STAFF RECOMMENDATION

**215 Carden Avenue
February 21, 2018**

Application: New construction – addition; Setback determination
District: Whitland Neighborhood Conservation Zoning Overlay
Council District: 24
Map and Parcel Number: 10413003200
Applicant: Nancy Moore, The Porch Company
Project Lead: Melissa Sajid, melissa.sajid@nashville.gov

Description of Project: The application is to construct a rear screened porch addition with a footprint of approximately three hundred and seven square feet (307 sq. ft.). The request includes a left side setback determination.

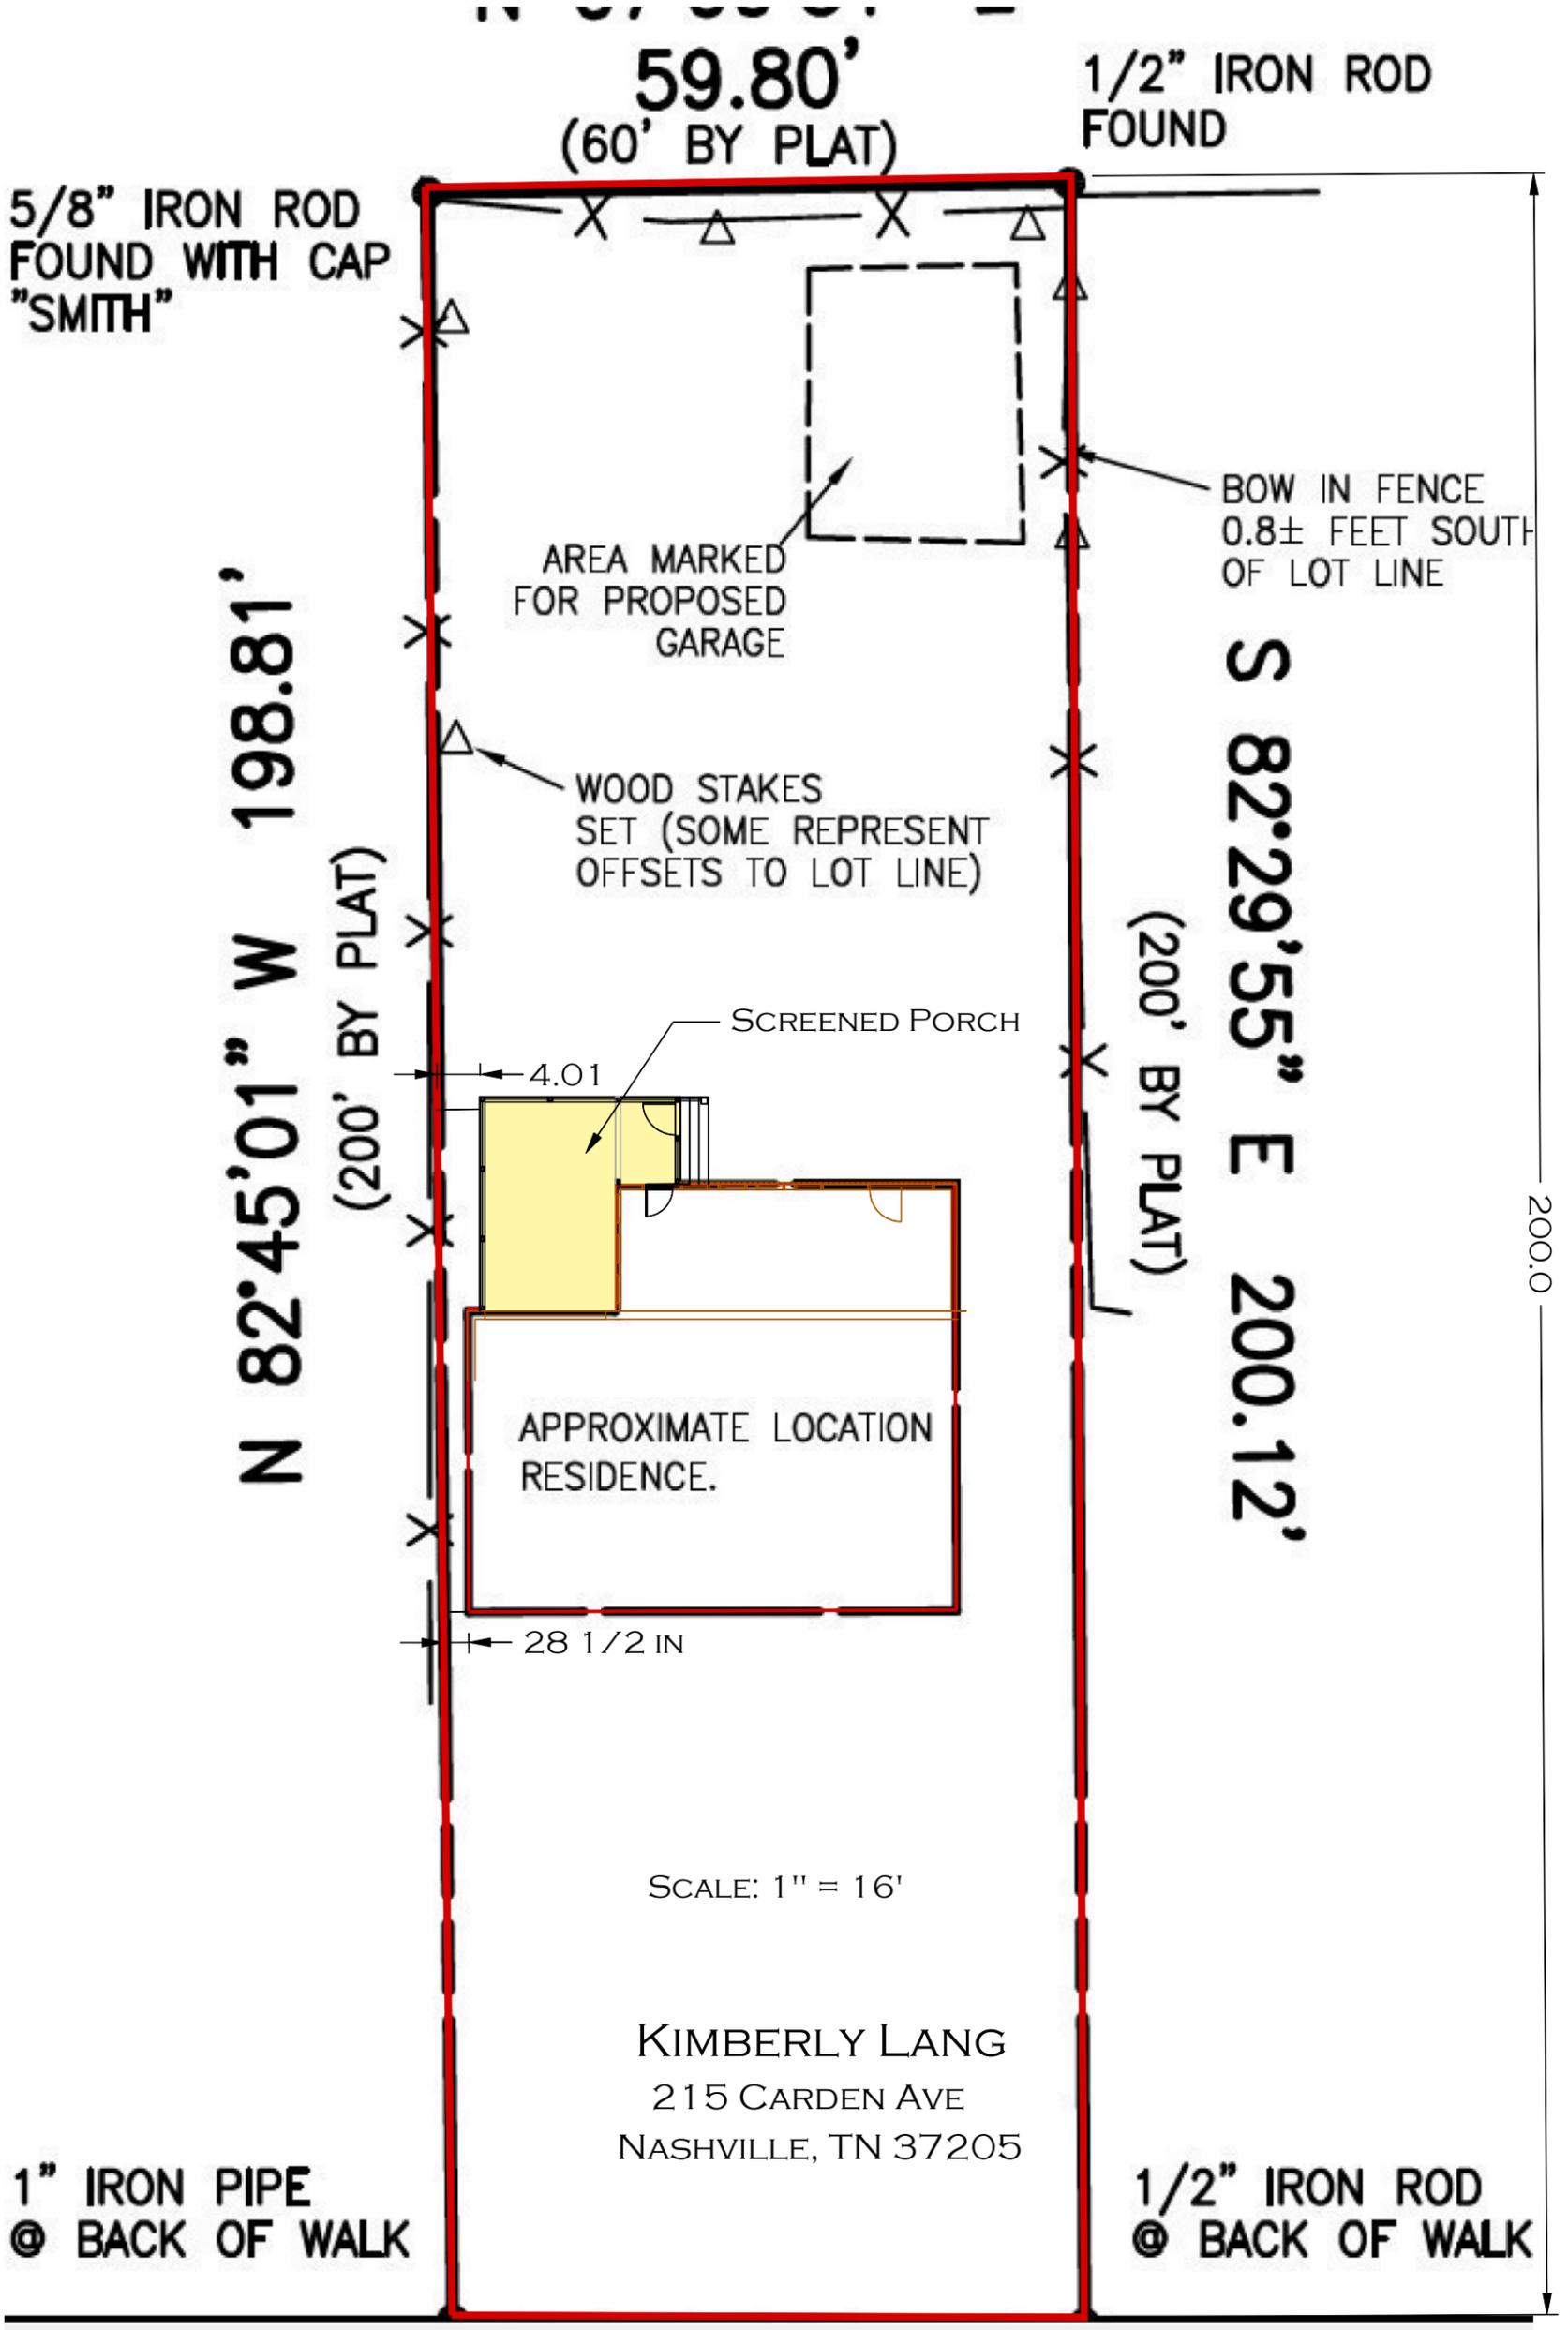
Roof form: The roof of the addition will be hipped with a 6:12 pitch to match that of the existing rear gable. The shed roof form of the existing rear addition will be extended to connect to the proposed addition.

The project meets section II.B.1.e.

PLAN VIEW
 Scale: 1/4" = 1'

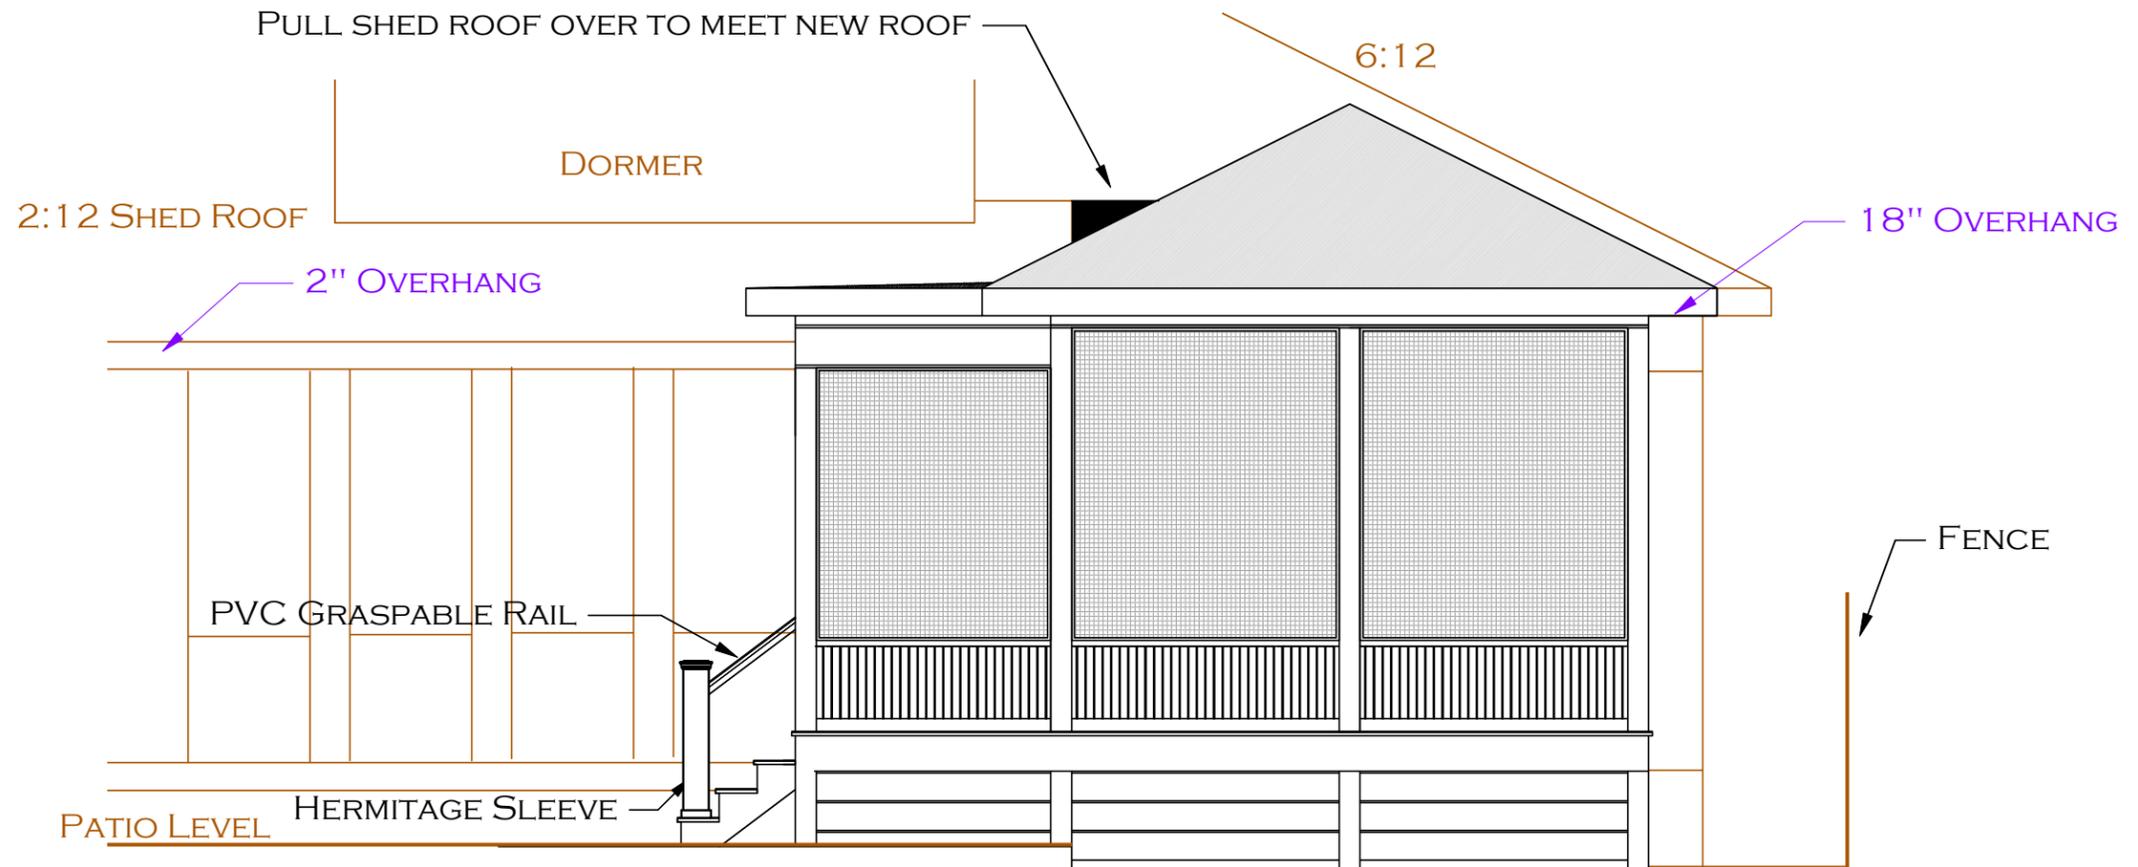
Location & Removability: The new addition will be at the rear of the existing building, stepped in from the side wall of the original house by one foot (1') on the left side of the house and tie into a non-contributing rear addition on the right side. The roof of the new addition will tie into the rear slope of the original roof more than six inches (6") below the ridge. By attaching in this manner, the addition does not impact the original building and if it were to be removed in the future the original form would be left intact. The project meets section II.B.2.a and d.

Setbacks: The new addition meets the rear and right side setbacks as required by the base zoning but does not meet the left side setback. The applicant requests a setback determination to reduce the left side setback from five feet (5') to four feet (4'). The addition is located approximately eighty-four feet (84') from the rear property line and thirty-seven feet (37') from the right side property line. On the left side, the addition is approximately four feet (4') from the property line. Staff finds that the proposed left side setback is appropriate as the addition will be no closer to the property line than the existing house.

The project meets section II.B.1.c.
